1. 19-0980CA/MA; 110 Riverside Ave (NAC-R, Ward 1E) Sisters & Brothers Investment Group

Reapplication for 57 unit apartment building with underground parking. (Project Manager: Mary O'Neil)

To: Development Review Board
From: Mary O'Neil, AICP, Principal Planner
Date: July 16, 2019
RE: ZP19-0980CA/MA, 110 Riverside Avenue

BASEMENT
PARKING
PLAN

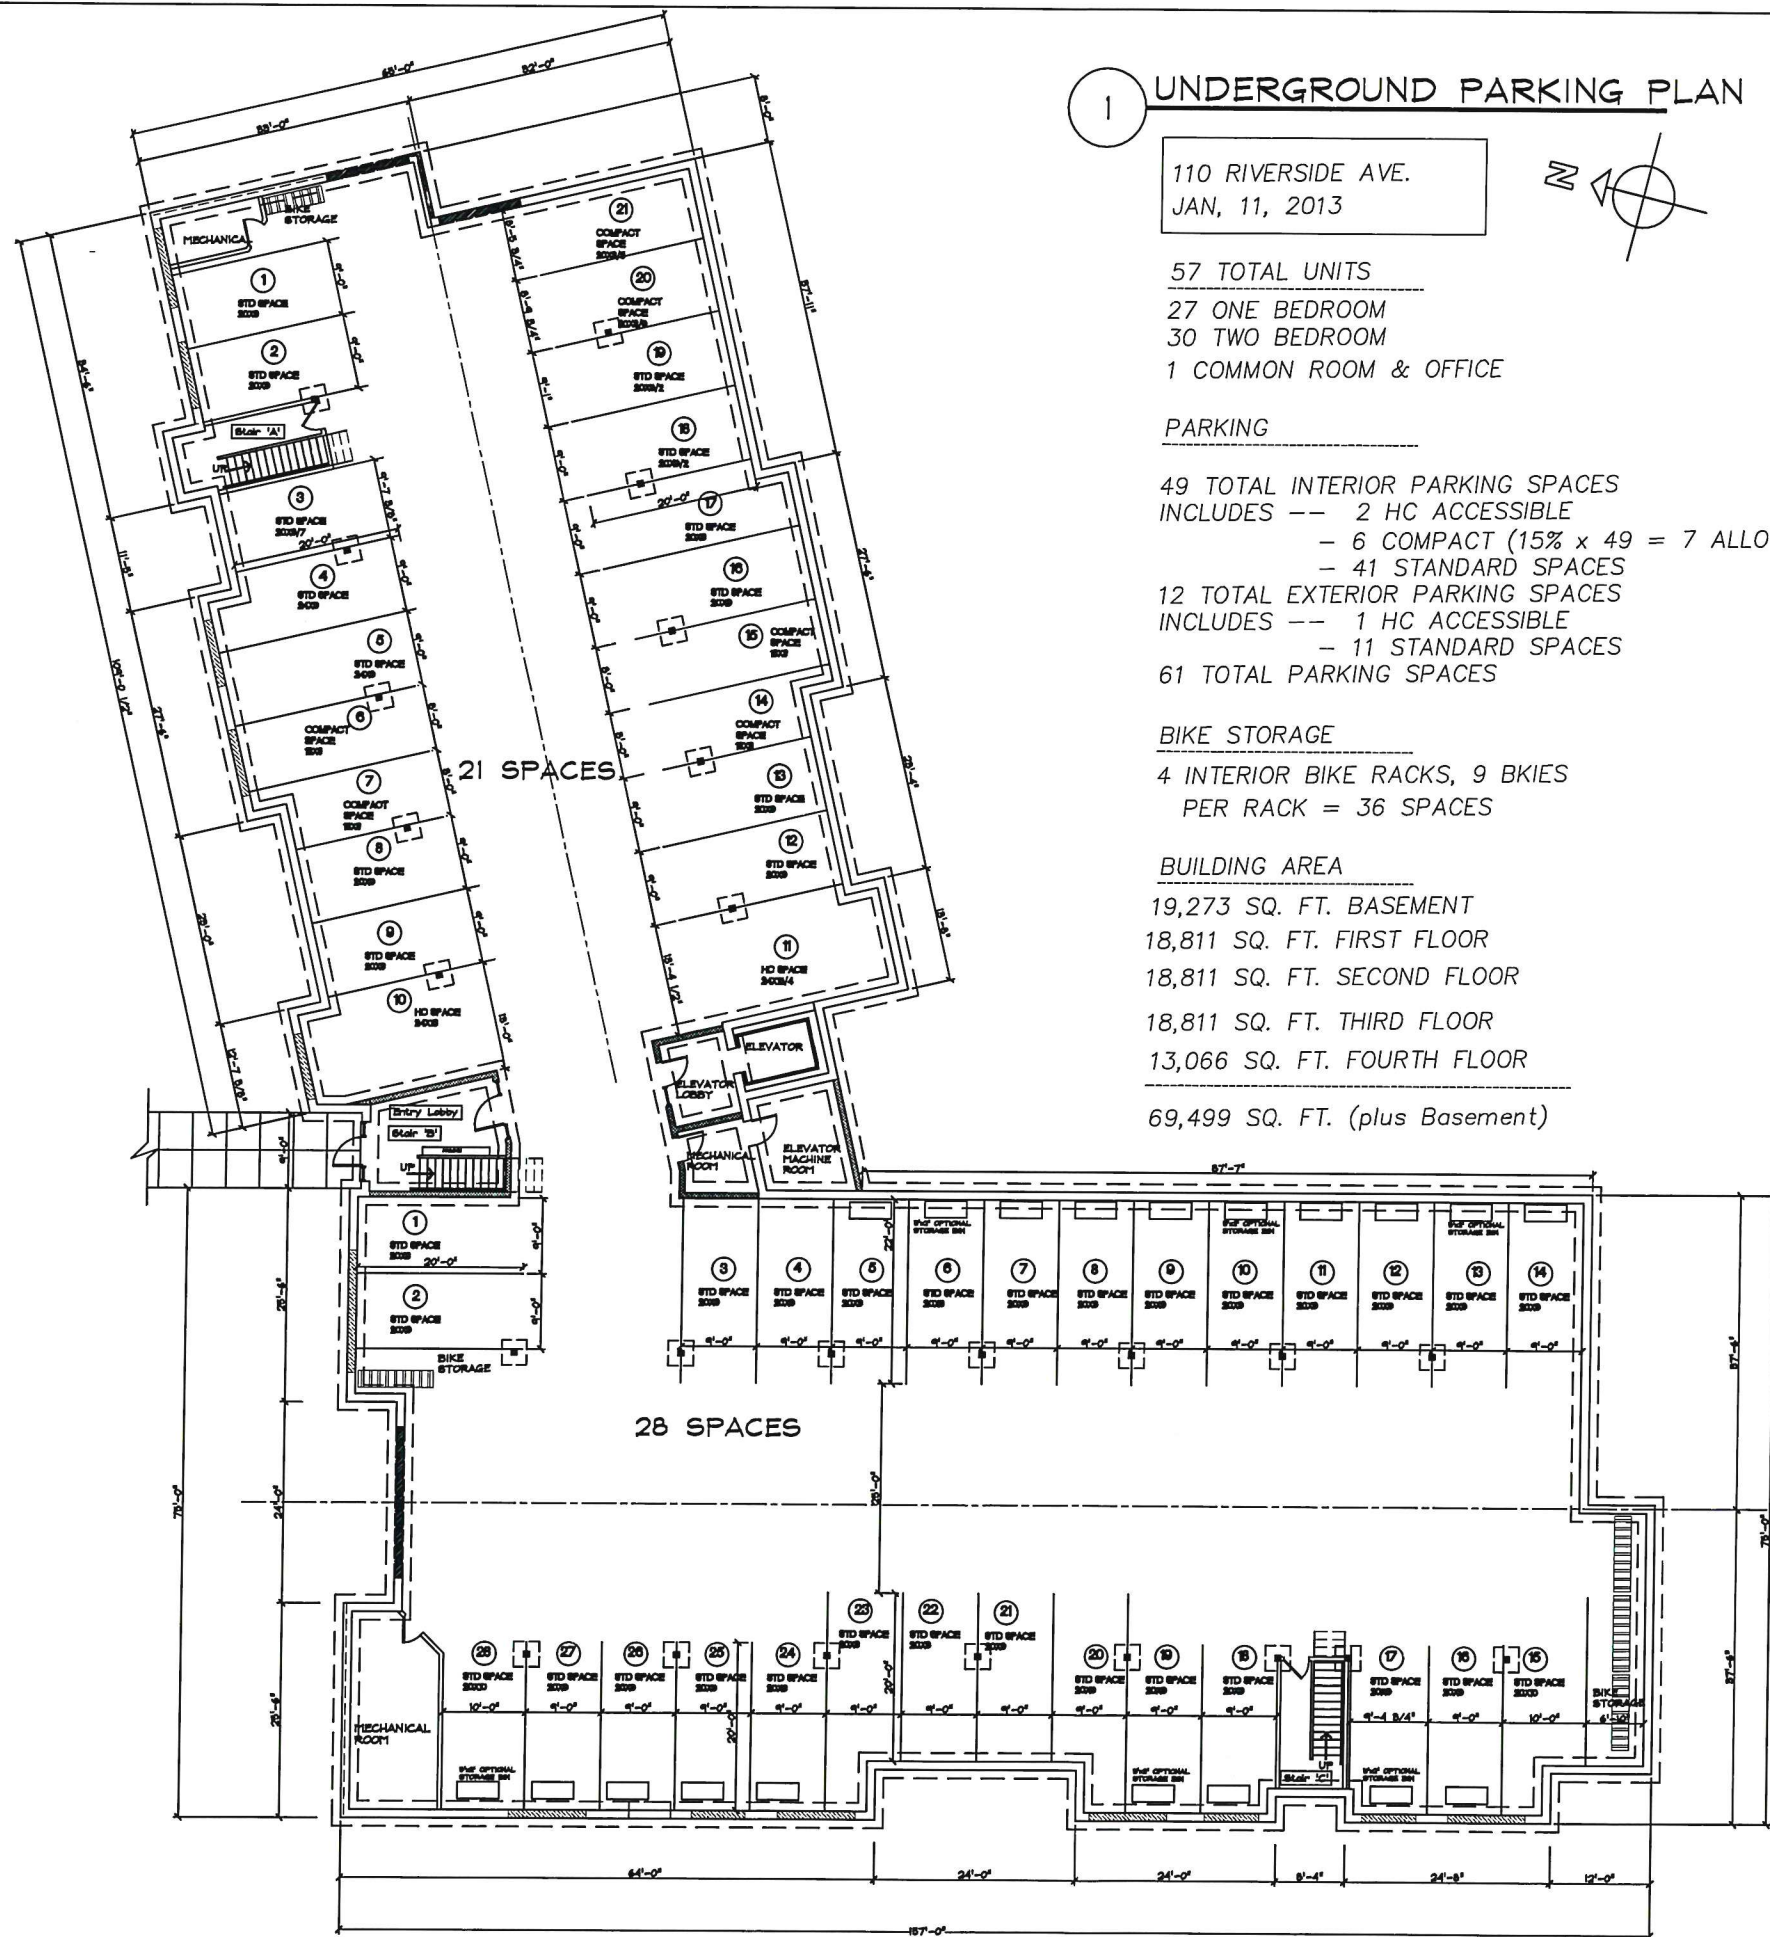
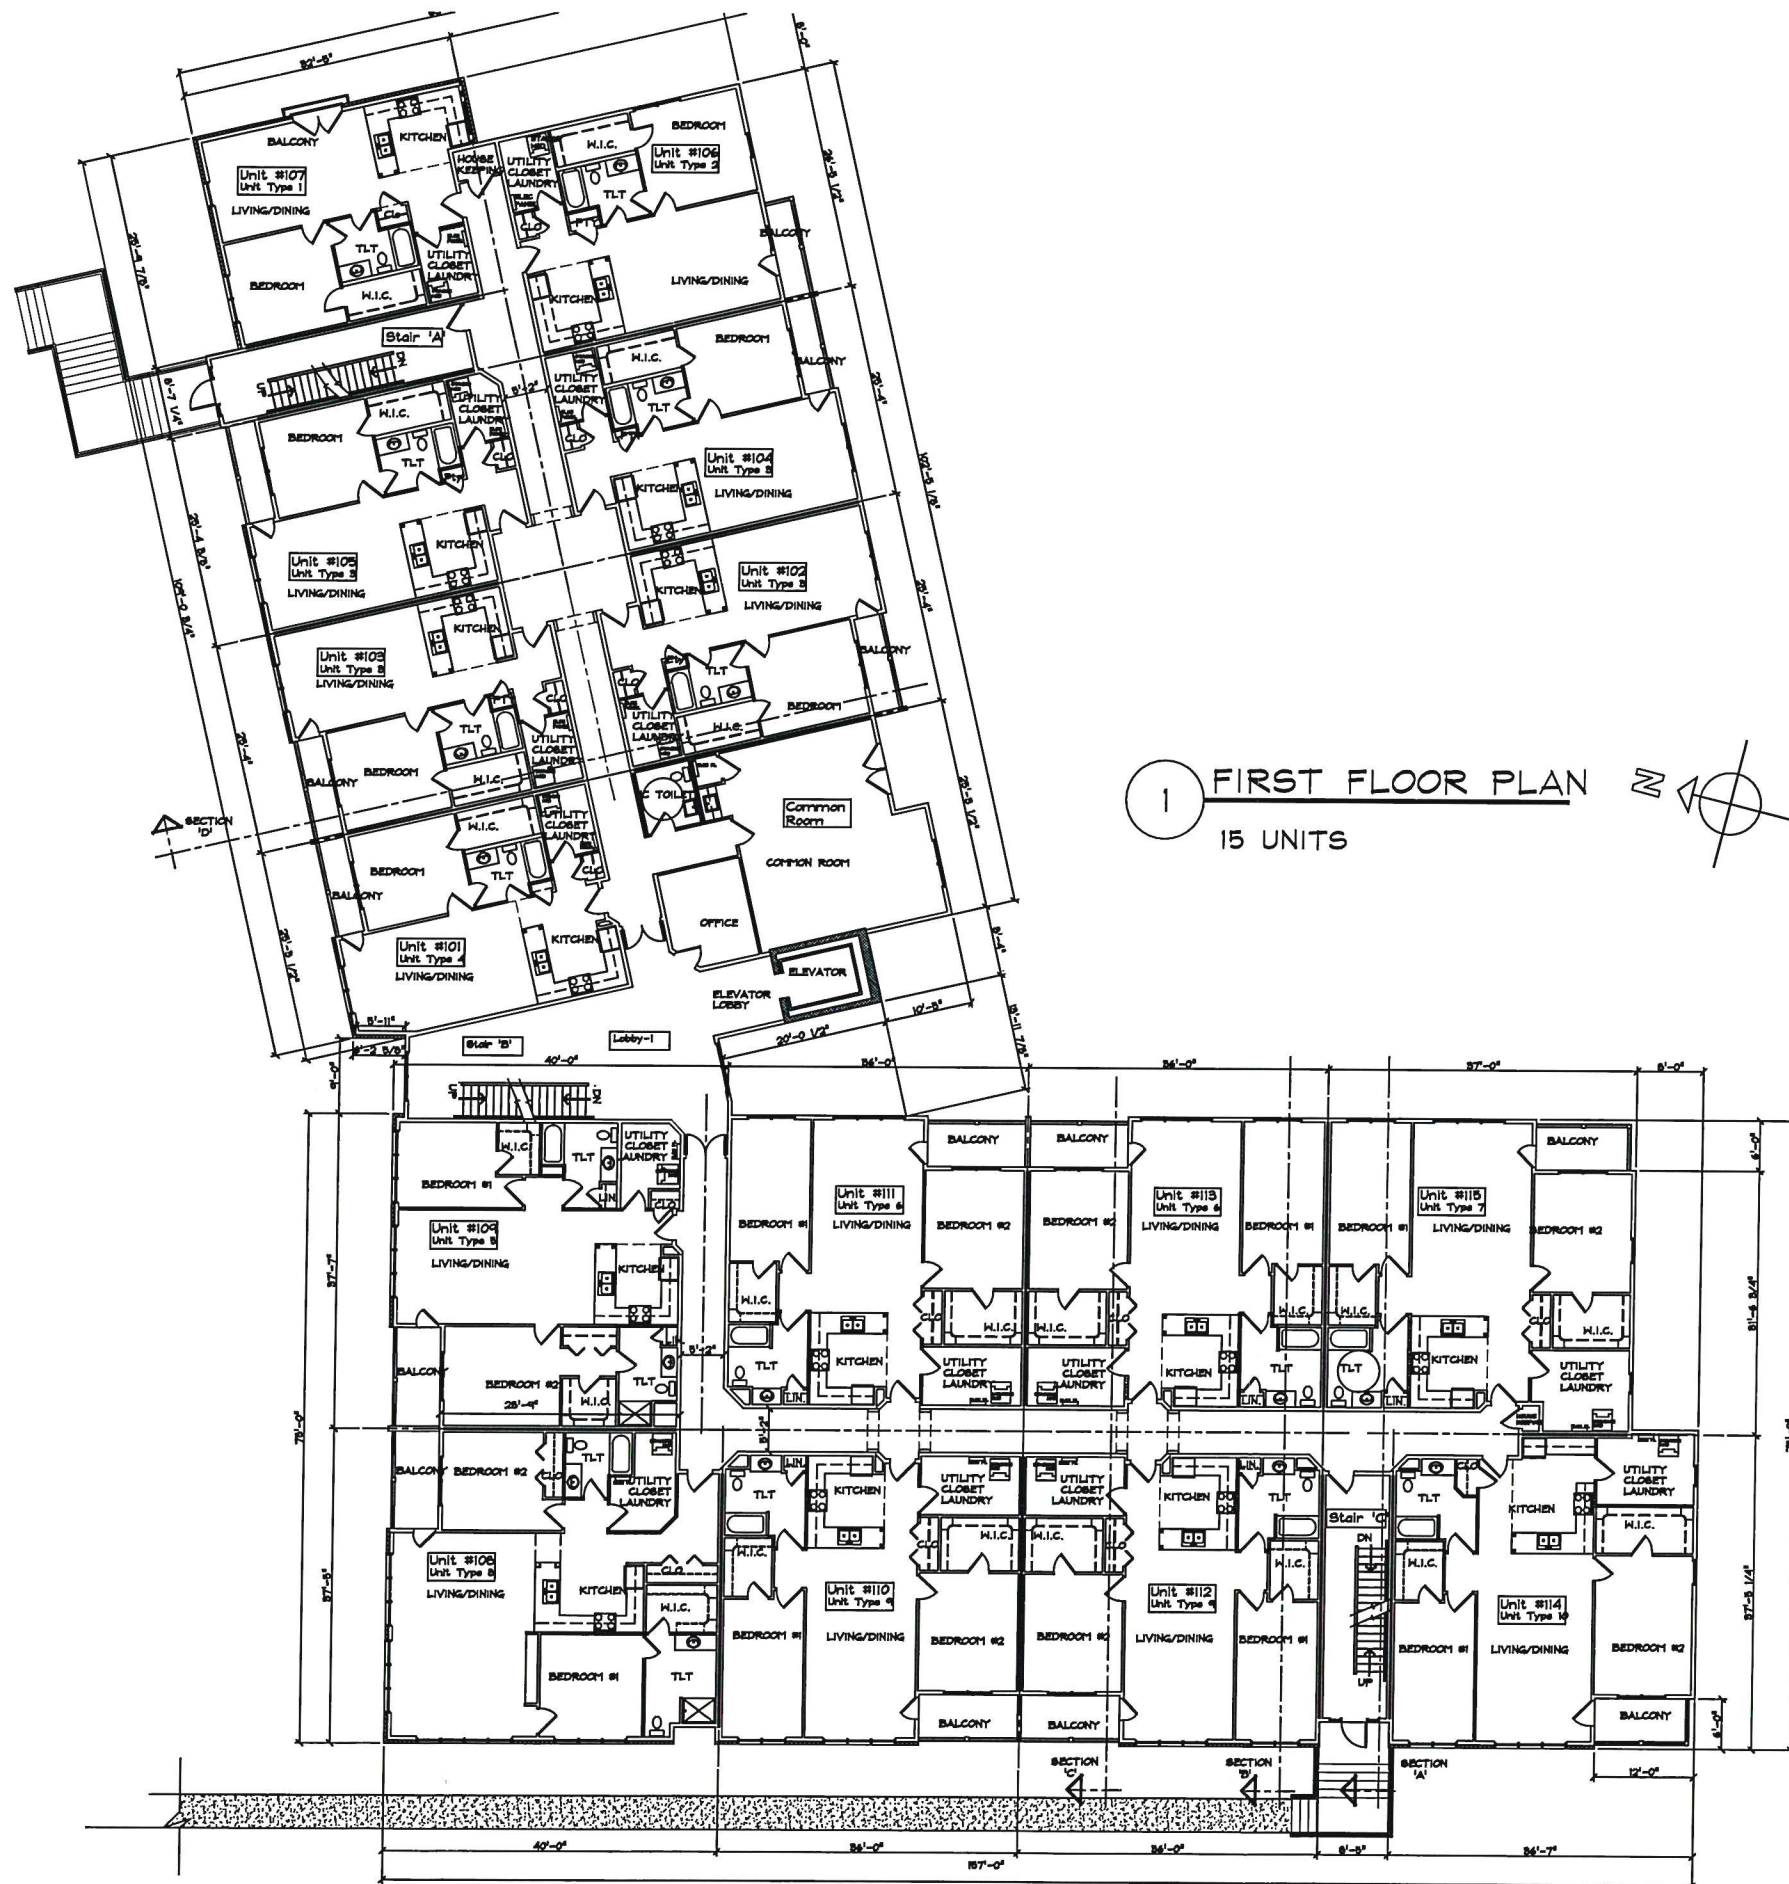
The plan proposes 6 compact parking spaces within the underground lot (per Plan A1-1), which is compliant with the 15% limitation under Article 8. A maximum of 7 compact spaces may be provided (15% of 49 structured spaces.)

Plan A1-1 illustrates optional 5' x 2' storage bins within the parking spaces 5-28. This would render all of those spaces as compact (less than 20' in length), and therefore unacceptable. The storage bins shall be removed these spaces to render them compliant with parking space standards.

Bicycle parking is provided within the parking garage. Three locations have been identified on Plan A1-1. None provide secure storage (lockers or similar, as recommended by the Design Advisory Board.) From a use standpoint, the isolated location of bike storage facilities is not commensurate with the anticipated need and likely use of the facilities.
